**ADDENDUM NO. 4**  
**RFP 407-21**  
**SWEET APPLE ELEMENTARY SCHOOL RENOVATION**

**ADDENDUM NO. 4, dated 10-23-20.**

RE: HVAC Replacement at  
Sweet Apple Elementary School

SHEET NO.: **E2.31**

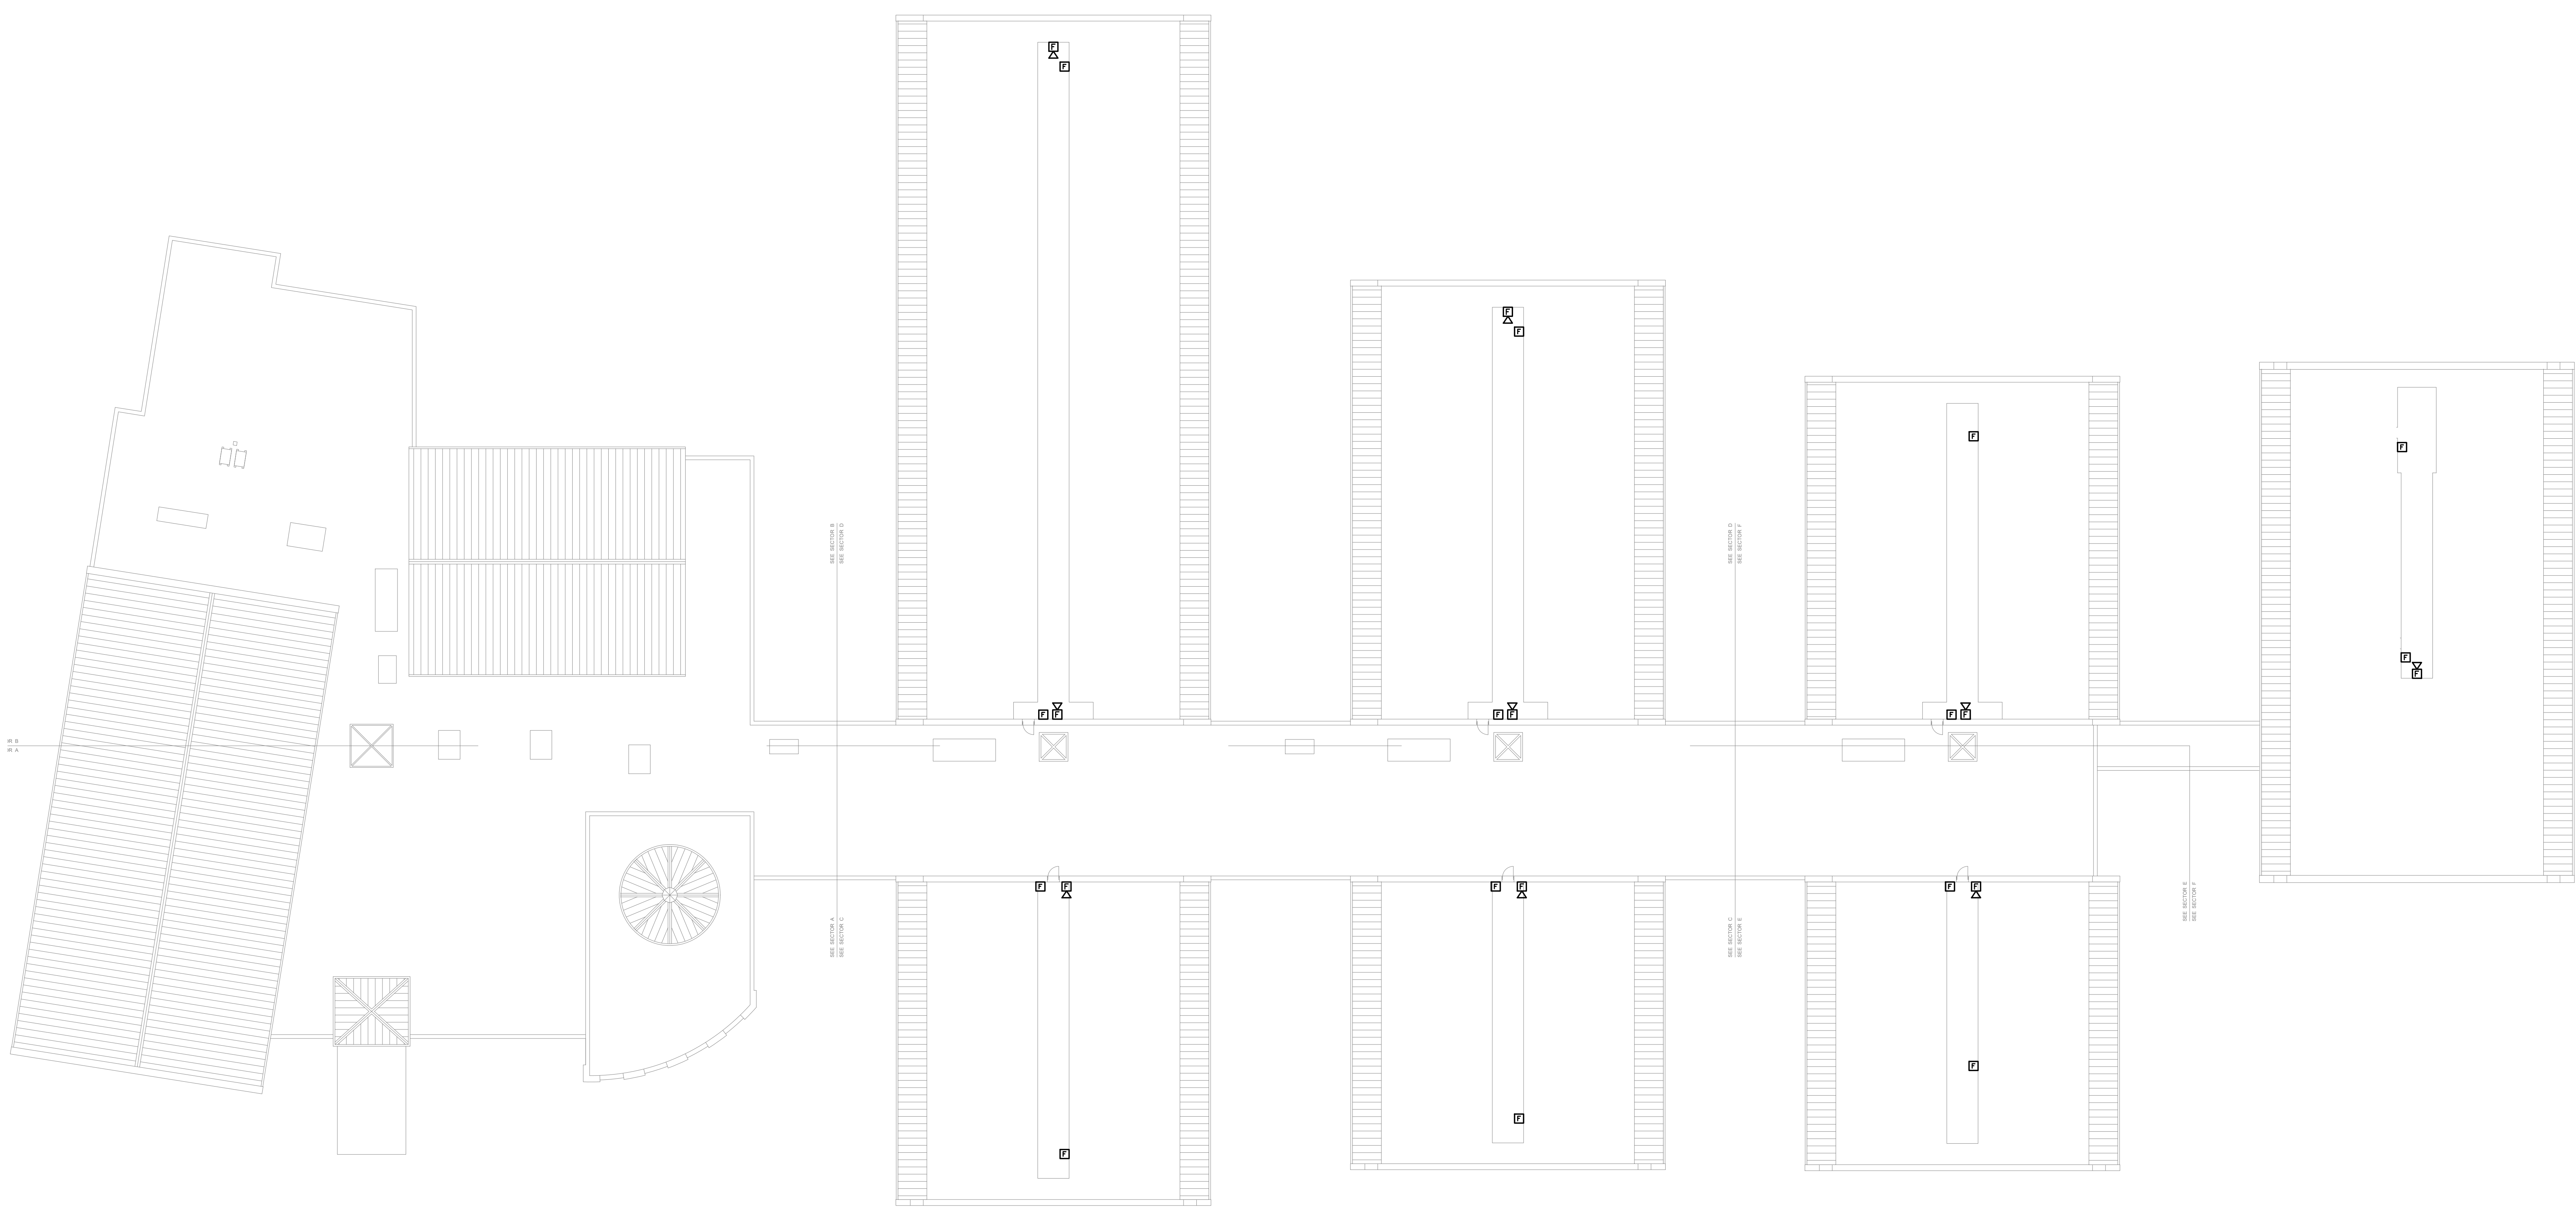
- A. CHANGES TO PROPOSAL REQUIREMENTS TABLE OF CONTENTS: None
- B. CHANGES TO PRIOR ADDENDUM: None
- C. CHANGES TO PROPOSAL DOCUMENTS: None
- D. CHANGES TO CONDITIONS OF THE CONTRACT: None
- E. CHANGES TO SPECIFICATIONS: None
- F. CHANGES TO DRAWINGS:
  - 1. Sheet E2.31
    - a. Add attached sheet “E2.31 - Electrical Overall Mezzanine and Roof Plan Fire Alarm”, dated 10-22-20.

- Response:  
Provide ceiling transition connector per detail 2/E2.21A
- RFI 07      Question:  
Please confirm that no notification appliances or initiating devices are required to be installed in the penthouse/catwalk areas.

- Response:  
See attached sheet E2.31 included in this addendum.
- RFI 08      Question:  
Please confirm that fire alarm monitoring is required for the new generator
